Roof Inspection Report
In respect of:

**Report produced by Simon
Hollis MRICS**

Drone Inspection Report - Summary of Findings

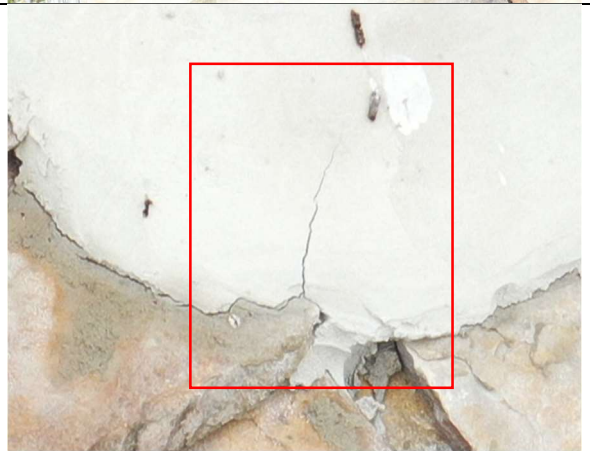
There should be a stepped lead flashing and soaker detail and a saddle piece here.

Flashings – there should be a front apron detail in lead on the fronts of the stack. Here, there just looks to be mortar.

Flashing – example of a hairline crack to the mortar on the front part of the stack.

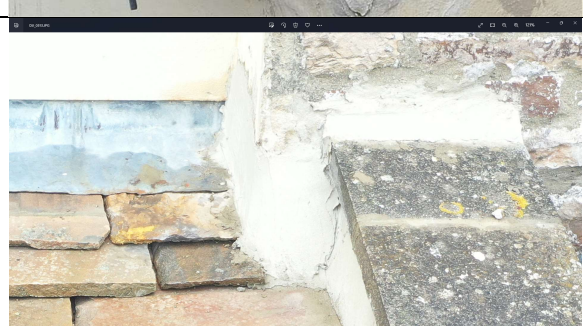
Un-necessarily large gaps between slates.

Poor bonding detail and inconsistent tooling of the side of the slate.

Parapet Wall – the mortar detailing in the inside and outside of the parapet wall looks poor.

We are not sure what this detailing around the abutments is.

We recommend it is removed and replaced in the appropriate lead detail.

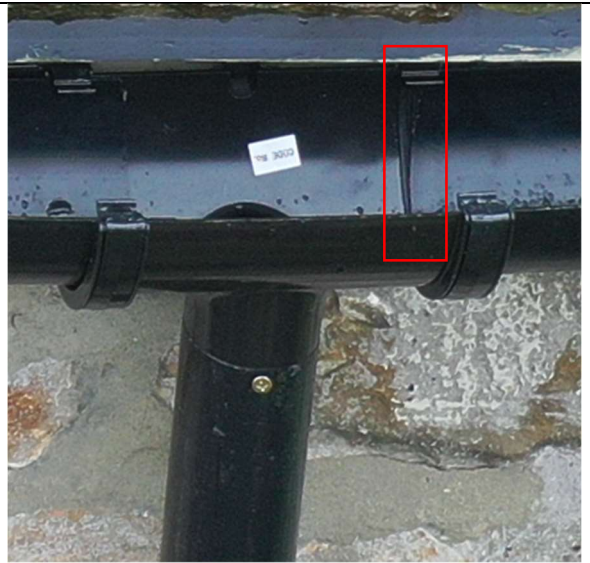
Front and rear elevations – the guttering is warped in places and does not sit square in all of the unions and outlets.

There are no pipes clips at the head of the fall pipes. The wood screw that has been fitted to hold the fall pipe to the outlet is inappropriate and will place additional pressure on the rise and fall brackets, outlets and guttering runs.
